#### CITY PLAN COMISSION REPORT

## Project Name ONE NINE VINE

5 CD-CPC-2021-0008 Rezoning to UR

RE: One Nine Vine UR Revision CD-CPC-2021-00008

**COVER SHEET**

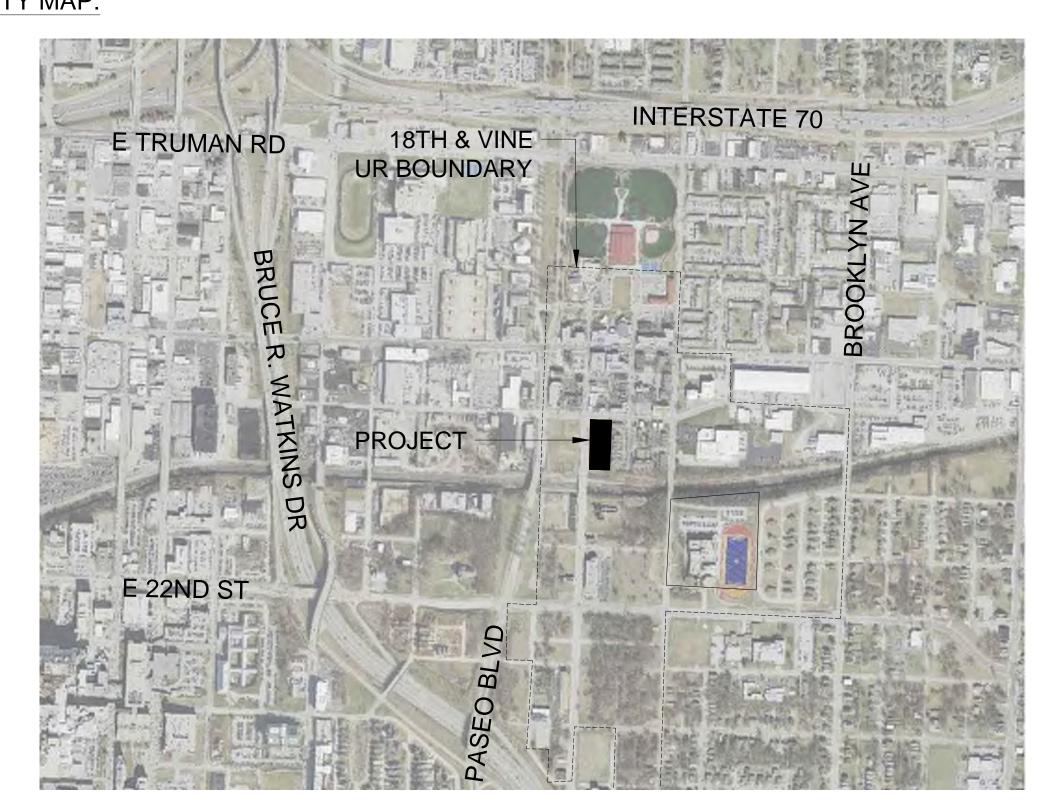
Revise the plan to show compliance with parking requirement per 88-420 prior to request for ordinance or obtain deviations from the city council.

Acknowledged, see revised Cover Sheet (CVR).

LANDSCAPE PLAN

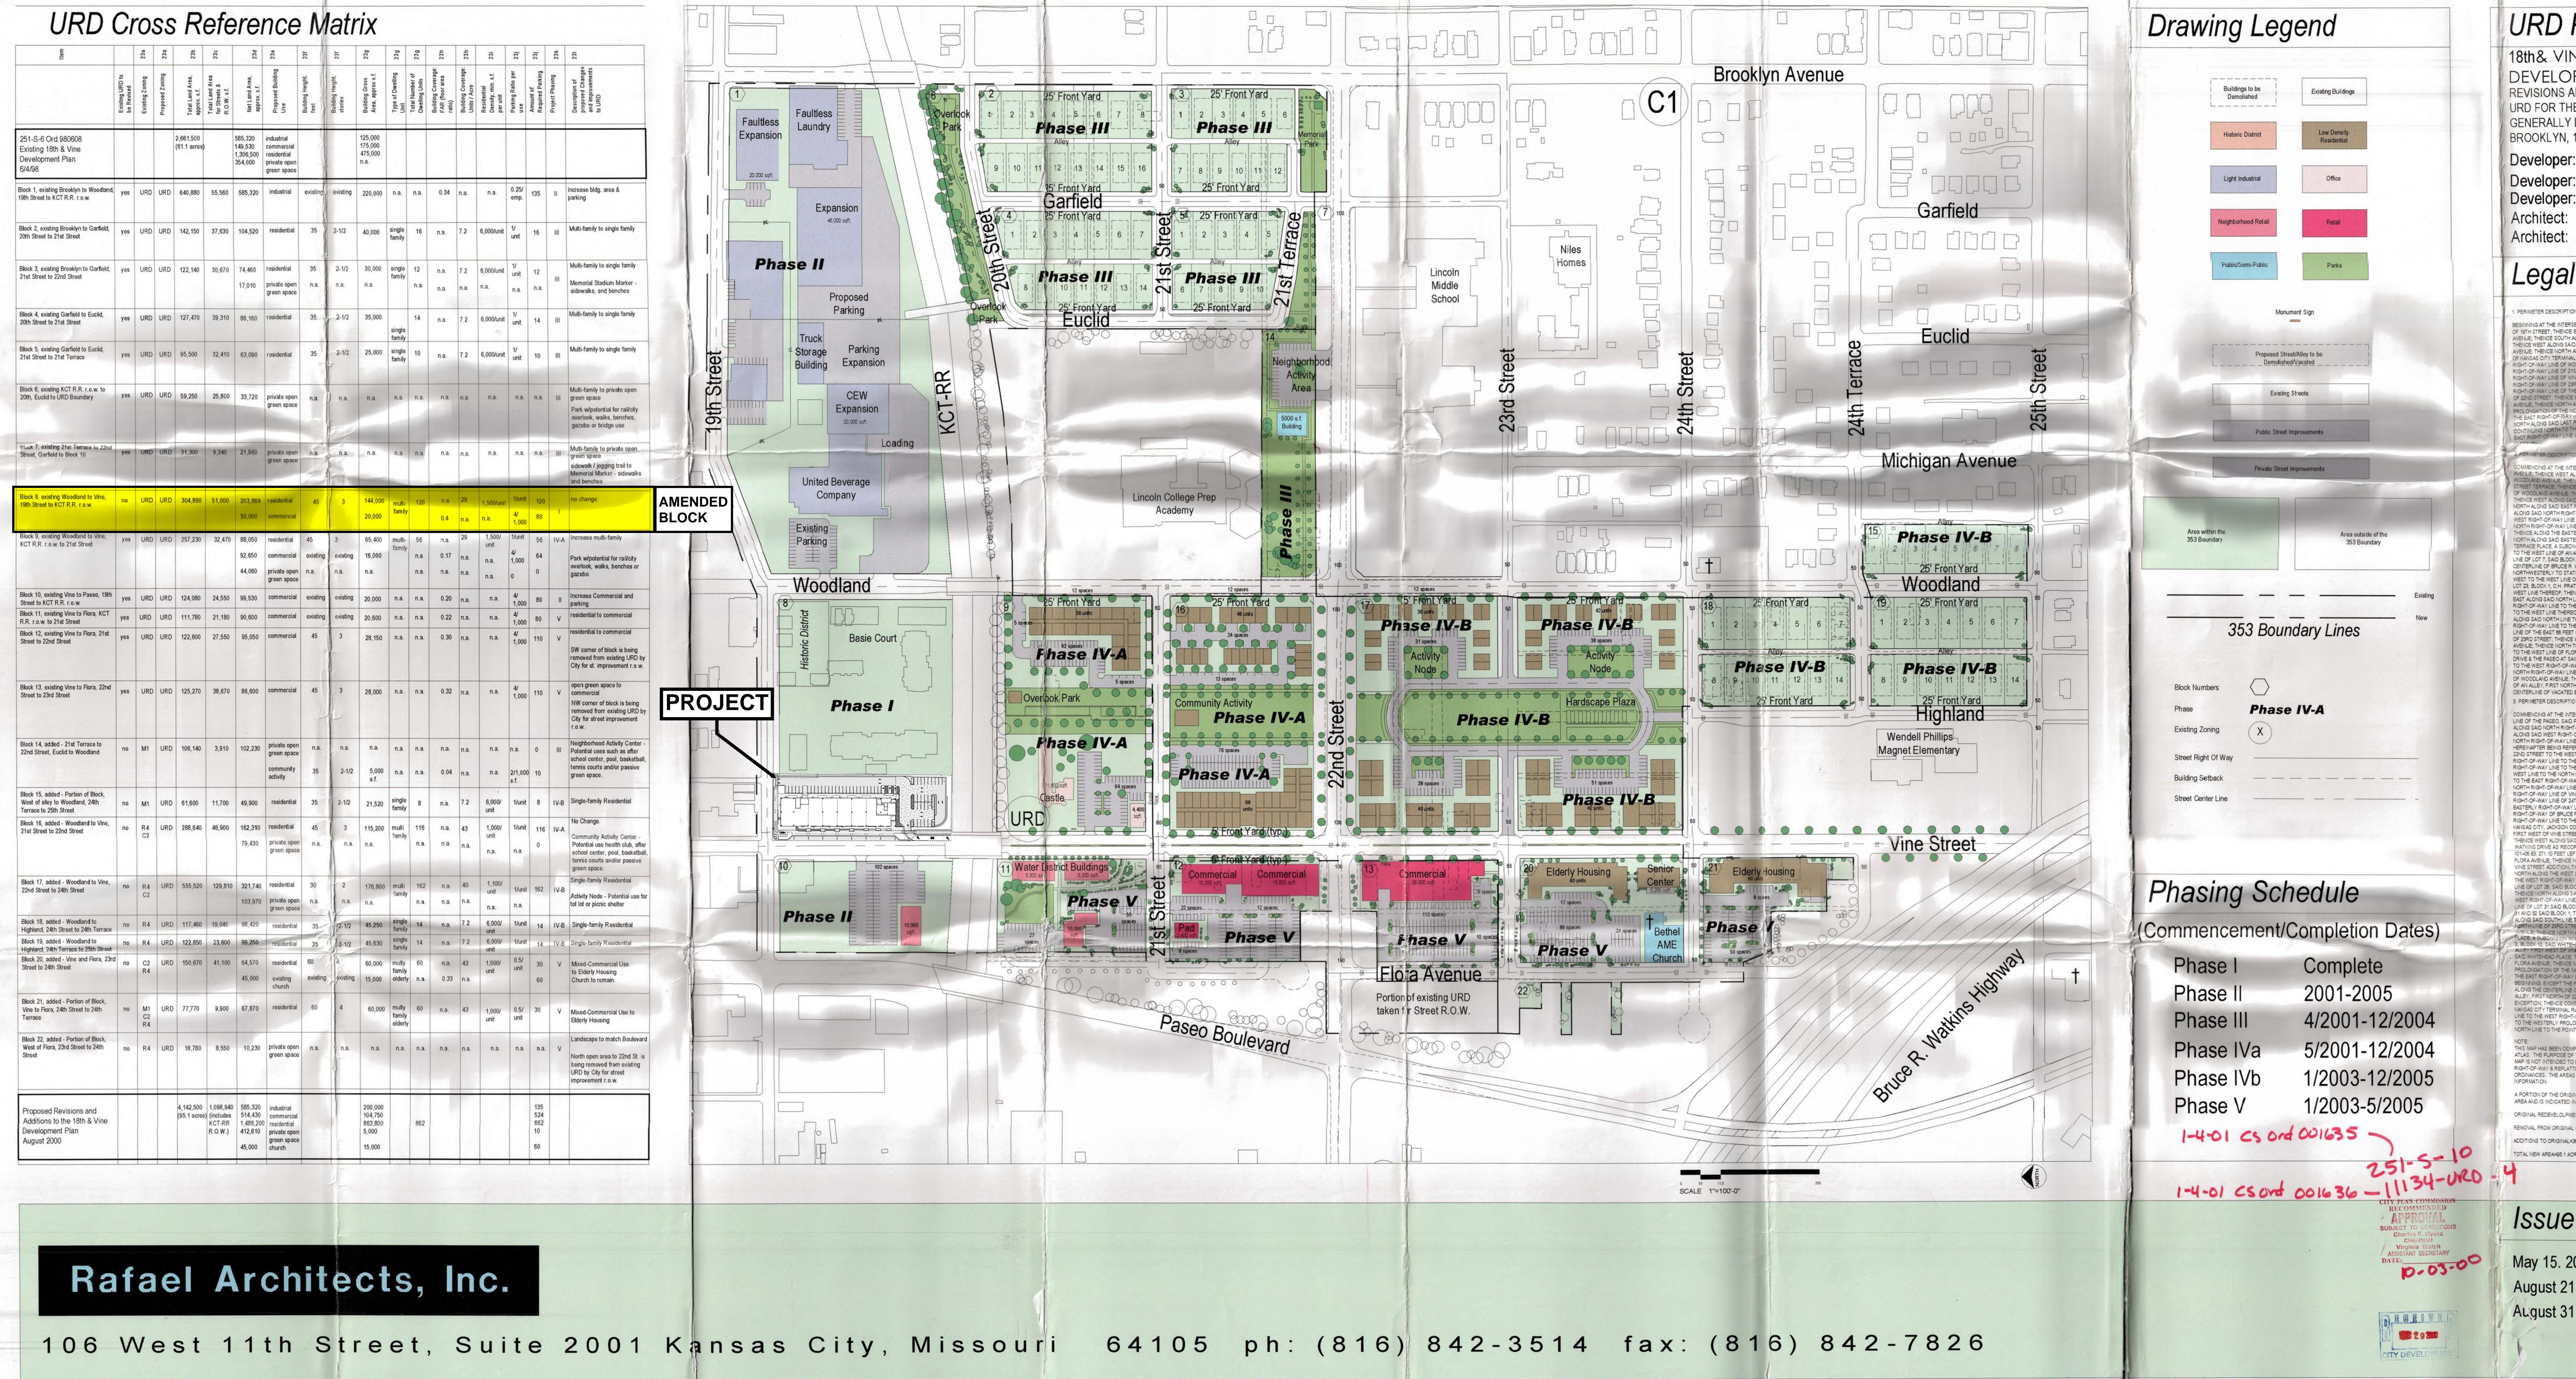
The applicant shall submit an application of administrative adjustment for alternative compliance for the landscape plan per discussion with staff.

Due to site geometry and project viability, limited opportunities exist for interior landscape areas. Per 88-425-13 - ADMINISTRATIVE ADJUSTMENTS FOR ALTERNATIVE COMPLIANCE, alternative landscape treatments may be considered by the city planning and development director. Treatments anticipated to be used on this project include raised planters on Vine Street frontage, pedestrian-scale lighting on both Vine Street and 19th Street frontages with integrated banner arms, benches and seating areas, metal fencing in front of parking on Vine Street frontage, art murals on building facade, enhanced island landscaping at public street bump-outs (at entrance off Vine and at intersection.)
